Doc or ECO #:	ECO-70041-006	Date:	2/9/2023	Author:	GD
	Rev. #:	A				
Discontinue using one of the approved Crystals	Engineering Approval:	aeg	Date:	5/4/2023	Quality Approval	aeg

P/N #:	Discontinue using one of the approved Crystals	Effective Date:	February 9, 2023
Title:	Discontinue using one of the approved Crystals (housing with metal can)

3.0 Detail

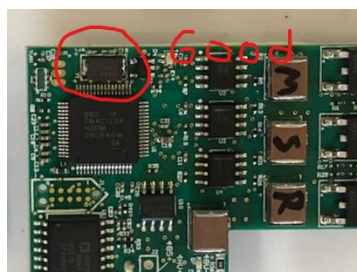
The MSS motor controller PCB electronics uses 16.0000MHZ 12PF SMD crystal at location Y1 on the PCB for the clock signal for microcontroller. Due to volatile component inventories, the following two crystals have been approved in the past:

ECS-160-12-30-AEM-TR (with metal can housing)

AA-16.000MALE-T (ceramic glass housing)

It turned out that ROV diving depths greater than 900m crush the metal can housing crystal causing the ROV to be inoperable. As a result, the BOM needed to be updated to use only one crystal (ceramic glass housing crystal). The ceramic glass crystal have been tested for 2km depth and approved.

VR Inventory: Pull out all 70041 PCBs with metal can crystal and replace with ceramic glass crystal.
